Masihata Sweaters Ltd. (Extension)

South Panishail, Kashimpur, BKSP, Gazipur.

15 November 2023

2. Observations

Design strength considered in structural drawing

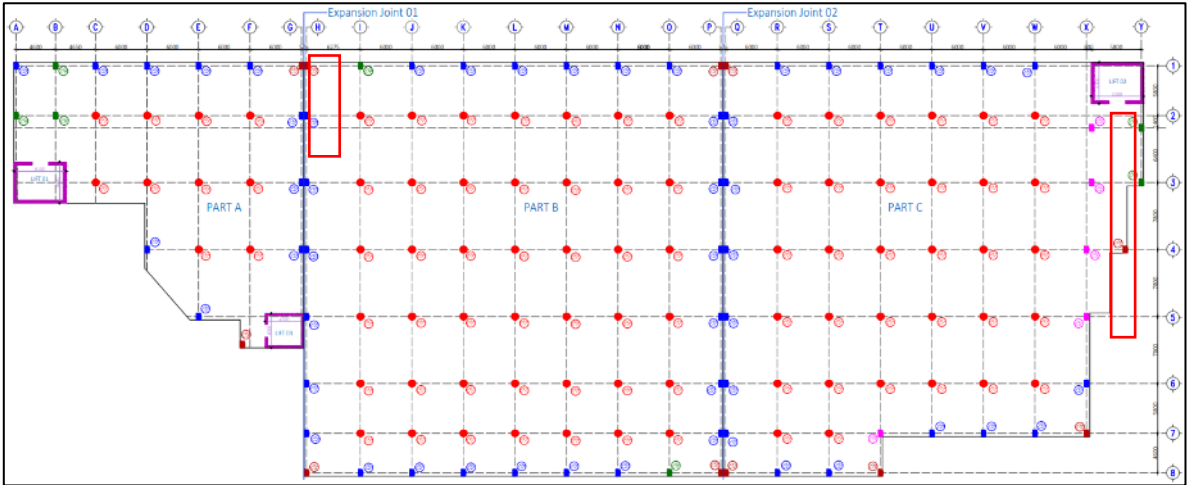
In the design report, concrete strength considered 24.1 MPa for column & shear wall and 415MPa for rebar but in structural drawing, design strength mentioned 31.03 MPa concrete and 496 MPa for rebar.

Description: The building engineer is required to revise the report with proper justification regarding special moment resisting frame, revise loading condition as per BNBC-2020 and confirm the design strength of concrete from concrete cylinder test report.

Column Schedule

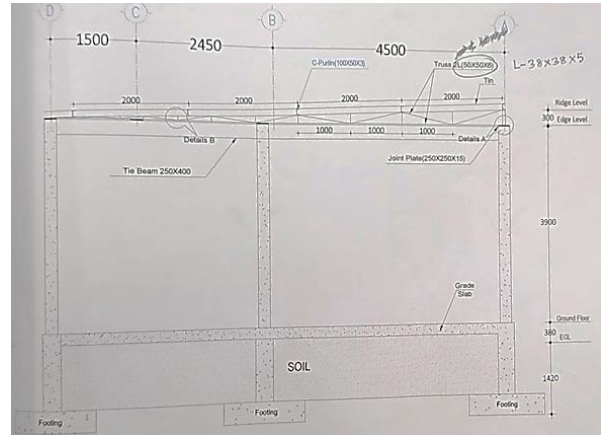
C2 column-16 nos of rebar found instead of 18 nos rebar.

C5 column-18 nos of rebar found instead of 24 nos rebar.

Description: During inspection, mismatches were found between onsite condition and as-built drawing. Rebar numbers of C2, C5 and C6 column found different from column schedule. The building engineer is required to survey the full structure and produce accurate as-built drawings.

Observation-4: Dampness on brick wall (Building-3).

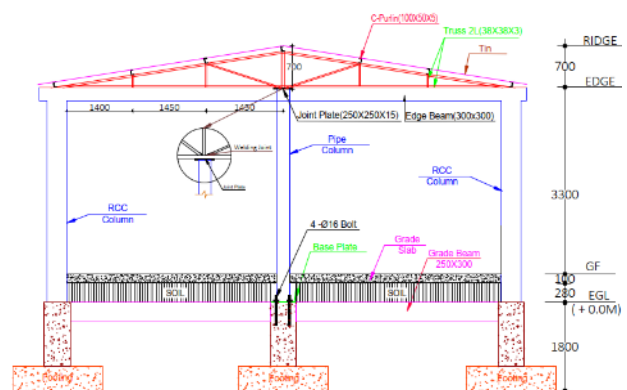
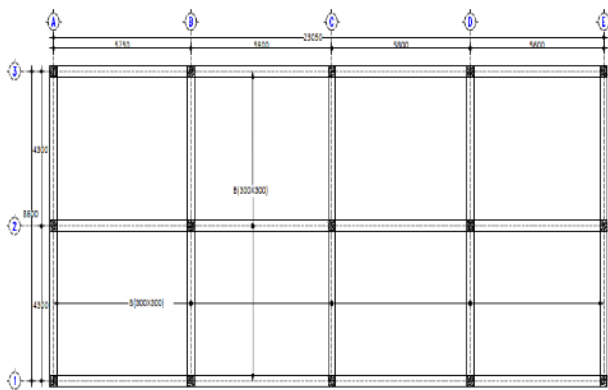
Description: Dampness observed on brick wall. Building engineer is required to repair the dampness.

Beam aggregate-Brick chips

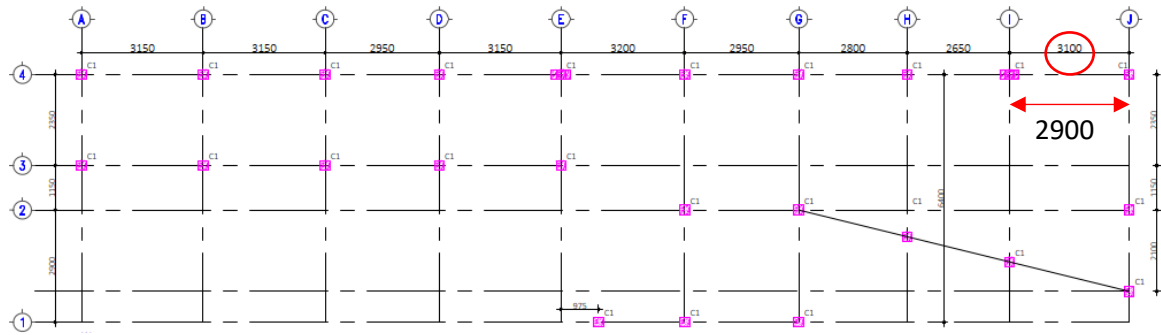
Observations: Stone chips aggregate has been used for the construction of the utility building but one of the beam was found made of brick chips. Building engineer is required to identify all the locations where brick chips has been used.

During inspection, total eight sets of the cylinder test of the report was available but only two sets (one set from Column and one set from footing) of the cylinder test report having average strength. The frequency of test for the cylinder test report does not comply with BNBC.

The provided design documents does not contains any FEA model. Building engineer is required to update the design documents based on in-situ strenth and submit to RSC.

Grid distance mismatch

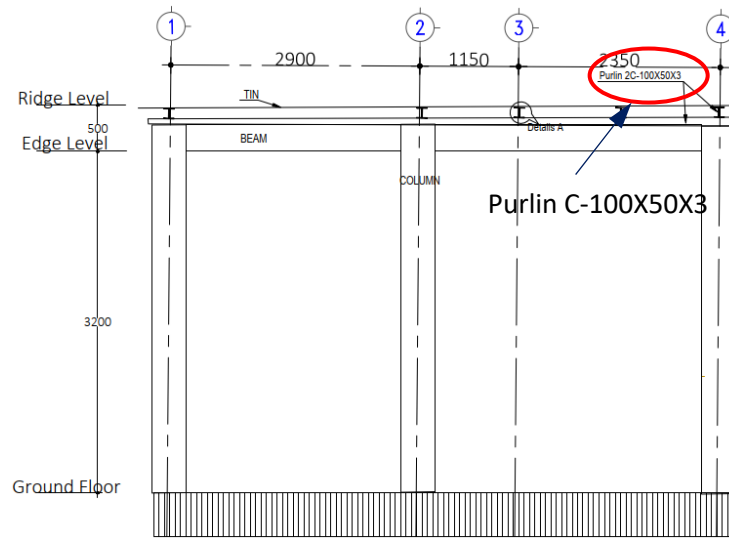
Observations: During inspection, discrepancy observed in as-built drawings. Grid distance mismatch was found at some locations. As per drawing, purlin size is 2C-100X50X3 but purlin size was found C-100X50X3 on-site. The building engineer is required to prepare accurate as built drawings and revise the design report.

Edge beam layout (as per structural drawing)

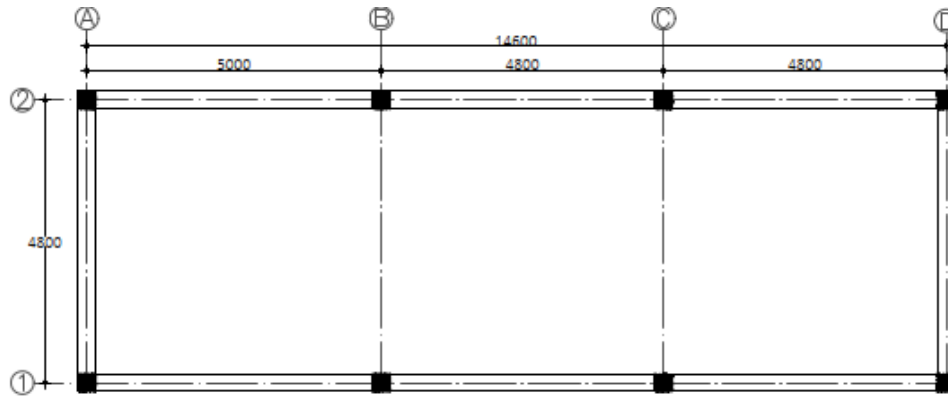
Missing edge beams at on-site condition

Description: According to the on-site condition, there is no edge beam at eave height level. Building engineer is required to prepare accurate as built drawings and revise the design report.
